**Subject:** Transport Airplane Cabin Interiors  
Crashworthiness Handbook

**AC No:** 25-17A

**Change:** 1

2. **PRINCIPAL CHANGES.** Change 1 updates AC 25-17A, *Transport Airplane Cabin Interiors Crashworthiness Handbook*, dated May 18, 2009. We have added the change number and date of revision at the top of each changed page. We have also marked the changes with a vertical change bar in the margin. Specifically, Change 1 incorporates the following changes:

FIGURE 86-2 HEAD STRIKE ZONE FOR § 25.785

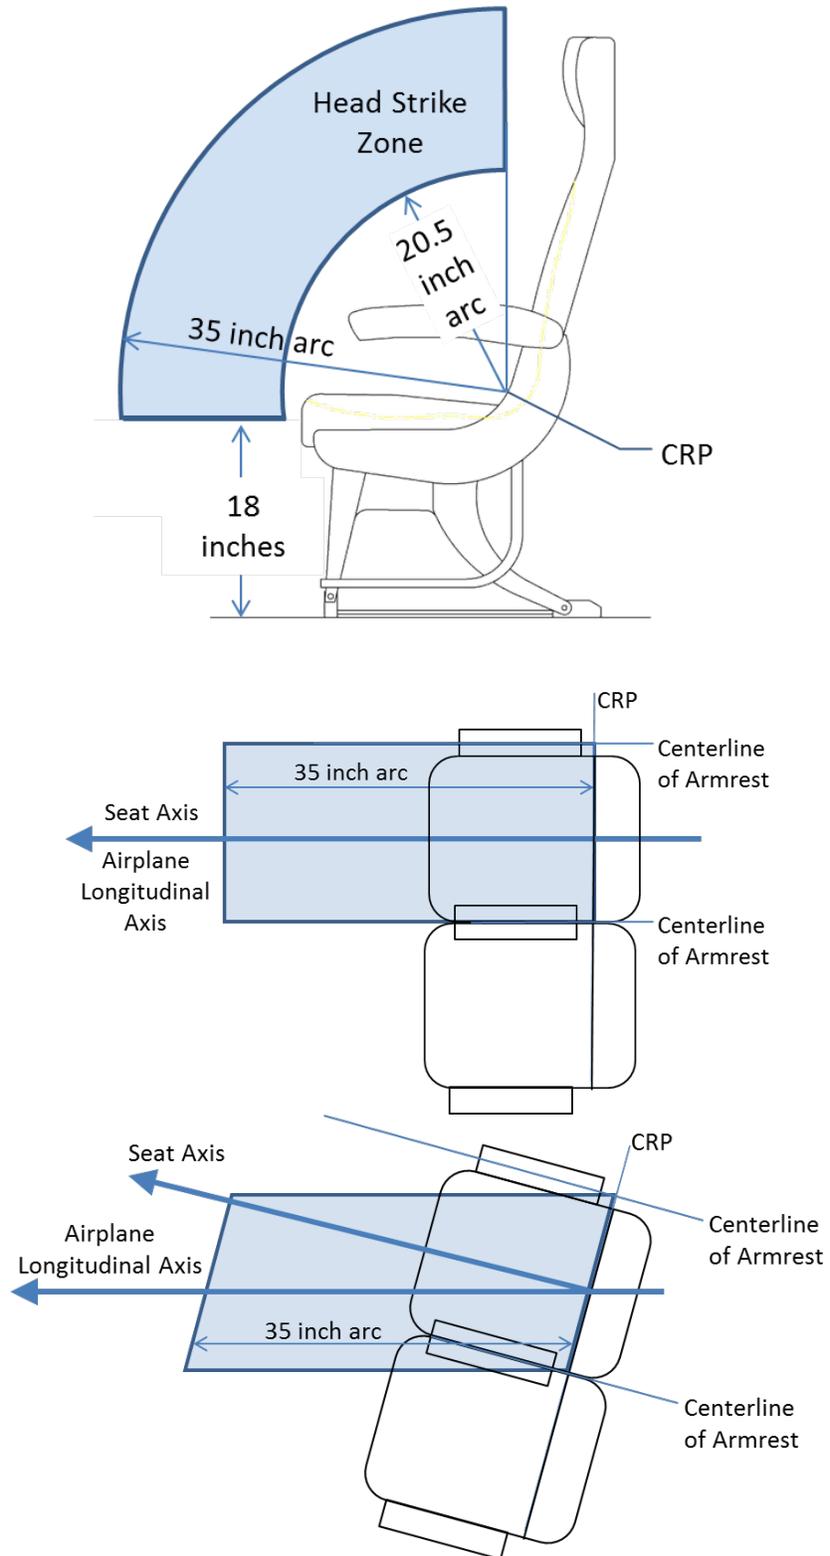
b. On pages 47, 60, 73, 86, 99, 113, 127 and 141, the figure showing the head strike zone is modified to show the zone is in the direction of the airplane longitudinal axis, and does not include those portions of the occupant's own seat that are very close to the seat back and seat bottom cushions.

(8) Paragraph (c)(2). The striking radius of the head for a forward facing seat (head strike zone) is considered to be a zone whose length is bounded between an arc at the shoulder height of the 5<sup>th</sup> percentile female occupant (20.5-inches) and an arc at the limit of the head path (35-inches), whose centers are at the intersection of the plane of the uncompressed top of the seat bottom cushion with the plane of the uncompressed front of the back cushion; commonly referred to as the cushion reference point (CRP), as shown in figure 86-2. Previously this was referred to as seat reference point (SRP). However, with the advent of dynamic seat testing the definition for SRP was changed (refer to SAE ARP5526D). The head strike zone extends in the direction parallel to the airplane longitudinal axis. The width of the head strike zone is bounded by a vertical plane through the intersection of the centerlines of each armrest and the CRP as shown in figure 86-2. Typical installations to be considered are bulkheads, cabinets, tables, and passenger evacuation slide covers. The installation should not contain any pointed corners or sharp edges. The testing used to demonstrate that the installation is not injurious must take into account whether the system (e.g., seatback mounted telephone) is allowed to be used during taxi, takeoff and landing. If the system is allowed to be used during these phases of operation, the testing must consider the system in both the deployed and stowed position (e.g., seatback mounted telephone in or out of the cradle). If a surface or interior feature is located such that it is potentially hazardous in a combination of forward and side loads, it should be substantiated even if it might be slightly outside of the head strike zone. Any surface less than 18-inches above the floor need not be considered. Surfaces within the head strike zone may be padded with energy absorbing material, such as one inch of either Ensolite (Type AH, AHC, IV3, HHC or HH), Klegecell, or Airex 4070. Foam rubber is not satisfactory since it is an energy storing material. If the padding is easily removed, there should be acceptable placarding requiring the padding be in place during taxi, takeoff, and landing. Compliance with § 25.562(c)(5) can be used to show compliance to § 25.785(c)(2) for those areas struck by the ATD head during dynamic testing.

FIGURE 87-2 HEAD STRIKE ZONE FOR § 25.785

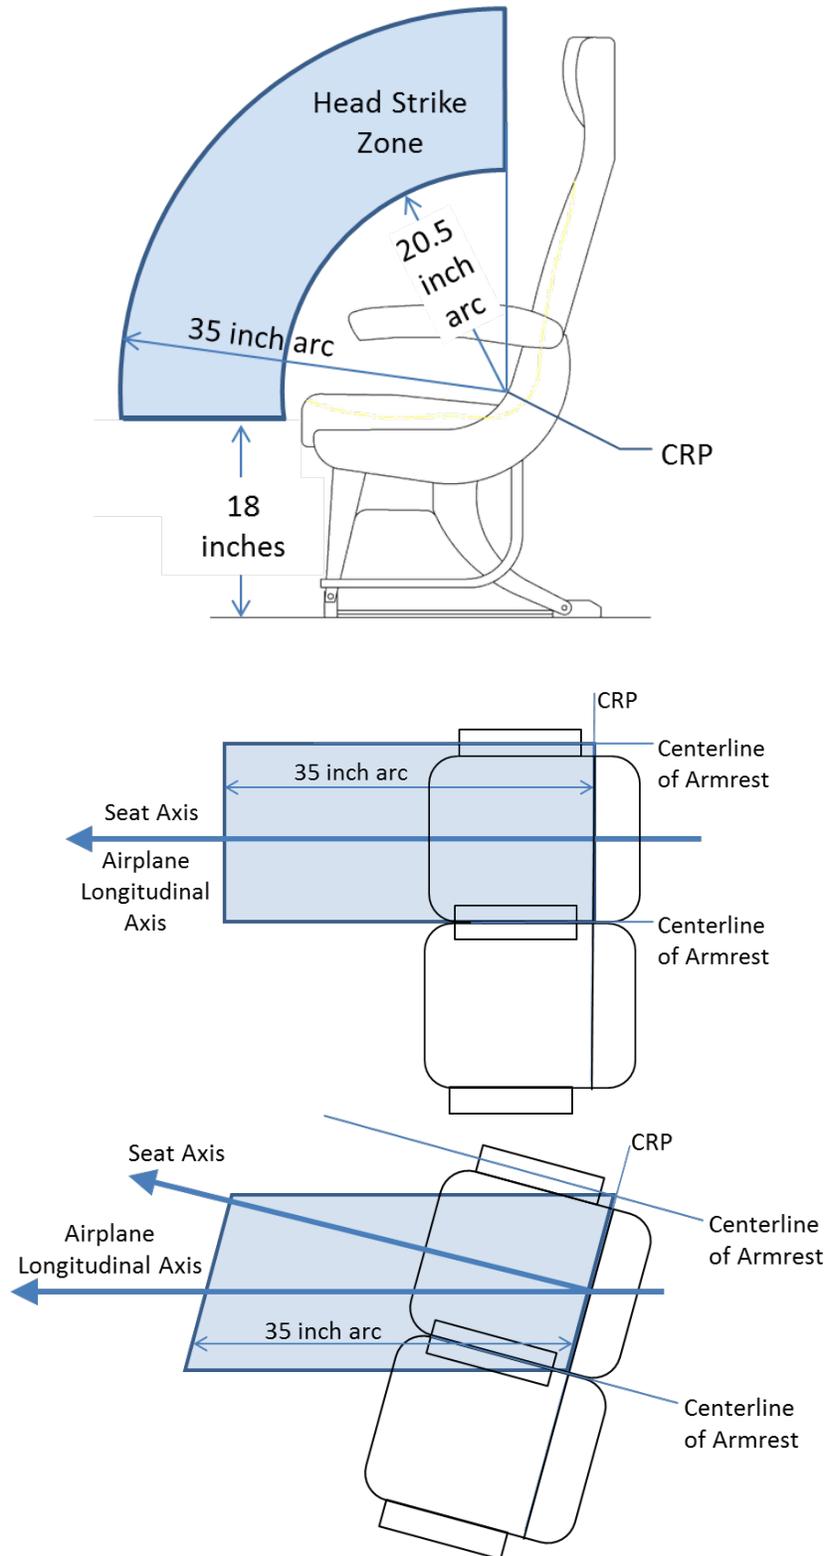
(8) Paragraph (d)(2). The striking radius of the head for a forward facing seat (head strike zone) is considered to be a zone whose length is bounded between an arc at the shoulder height of the 5<sup>th</sup> percentile female occupant (20.5-inches) and an arc at the limit of the head path (35-inches), whose centers are at the intersection of the plane of the uncompressed top of the seat bottom cushion with the plane of the uncompressed front of the back cushion; commonly referred to as the cushion reference point (CRP), as shown in figure 87-2. Previously this was referred to as seat reference point (SRP). However, with the advent of dynamic seat testing the definition for SRP was changed (refer to SAE ARP5526D). The head strike zone extends in the direction parallel to the airplane longitudinal axis. The width of the head strike zone is bounded by a vertical plane through the intersection of the centerlines of each armrest and the CRP as shown in figure 87-2. Typical installations to be considered are bulkheads, cabinets, tables, and passenger evacuation slide covers. The installation should not contain any pointed corners or sharp edges. The testing used to demonstrate that the installation is not injurious must take into account whether the system (e.g., seatback mounted telephone) is allowed to be used during taxi, takeoff and landing. If the system is allowed to be used during these phases of operation, the testing must consider the system in both the deployed and stowed position (e.g., seatback mounted telephone in or out of the cradle). If a surface or interior feature is located such that it is potentially hazardous in a combination of forward and side loads, it should be substantiated even if it might be slightly outside of the head strike zone. Any surface less than 18-inches above the floor need not be considered. Surfaces within the head strike zone may be padded with energy absorbing material, such as one inch of either Ensolite (Type AH, AHC, IV3, HHC or HH), Klegecell, or Airex 4070. Foam rubber is not satisfactory since it is an energy storing material. If the padding is easily removed, there should be acceptable placarding requiring the padding be in place during taxi, takeoff, and landing. Compliance with § 25.562(c)(5) can be used to show compliance to § 25.785(d)(2) for those areas struck by the ATD head during dynamic testing.

FIGURE 88-2 HEAD STRIKE ZONE FOR § 25.785

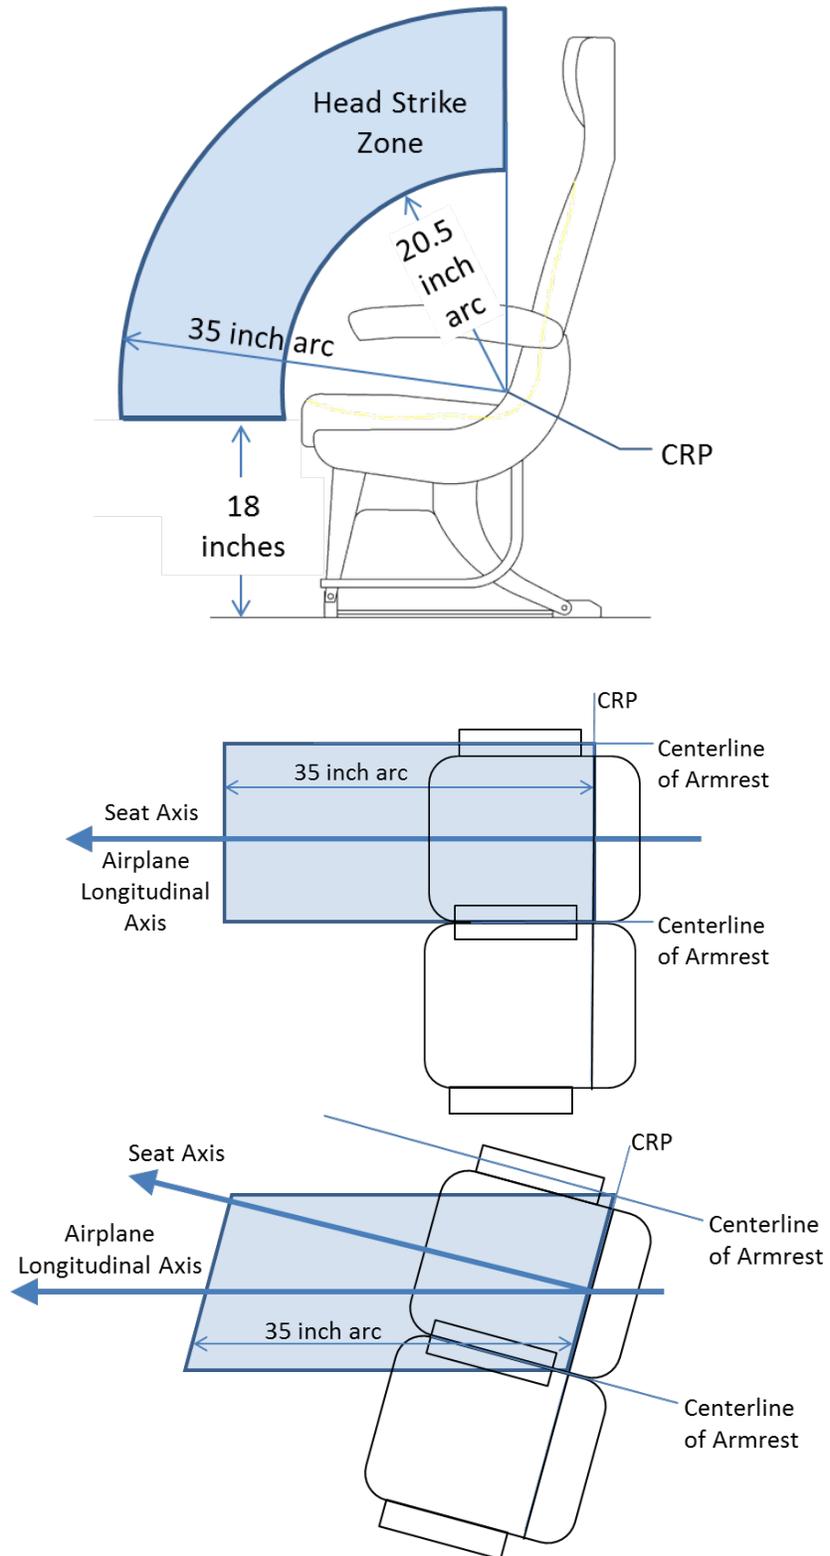
(8) Paragraph (d)(2). The striking radius of the head for a forward facing seat (head strike zone) is considered to be a zone whose length is bounded between an arc at the shoulder height of the 5<sup>th</sup> percentile female occupant (20.5-inches) and an arc at the limit of the head path (35-inches), whose centers are at the intersection of the plane of the uncompressed top of the seat bottom cushion with the plane of the uncompressed front of the back cushion; commonly referred to as the cushion reference point (CRP), as shown in figure 88-2. Previously this was referred to as seat reference point (SRP). However, with the advent of dynamic seat testing the definition for SRP was changed (refer to SAE ARP5526D). The head strike zone extends in the direction parallel to the airplane longitudinal axis. The width of the head strike zone is bounded by a vertical plane through the intersection of the centerlines of each armrest and the CRP as shown in figure 88-2. Typical installations to be considered are bulkheads, cabinets, tables, and passenger evacuation slide covers. The installation should not contain any pointed corners or sharp edges. The testing used to demonstrate that the installation is not injurious must take into account whether the system (e.g., seatback mounted telephone) is allowed to be used during taxi, takeoff and landing. If the system is allowed to be used during these phases of operation, the testing must consider the system in both the deployed and stowed position (e.g., seatback mounted telephone in or out of the cradle). If a surface or interior feature is located such that it is potentially hazardous in a combination of forward and side loads, it should be substantiated even if it might be slightly outside of the head strike zone. Any surface less than 18-inches above the floor need not be considered. Surfaces within the head strike zone may be padded with energy absorbing material, such as one inch of either Ensolite (Type AH, AHC, IV3, HHC or HH), Klegecell, or Airex 4070. Foam rubber is not satisfactory since it is an energy storing material. If the padding is easily removed, there should be acceptable placarding requiring the padding be in place during taxi, takeoff, and landing. Compliance with § 25.562(c)(5) can be used to show compliance to § 25.785(d)(2) for those areas struck by the ATD head during dynamic testing.
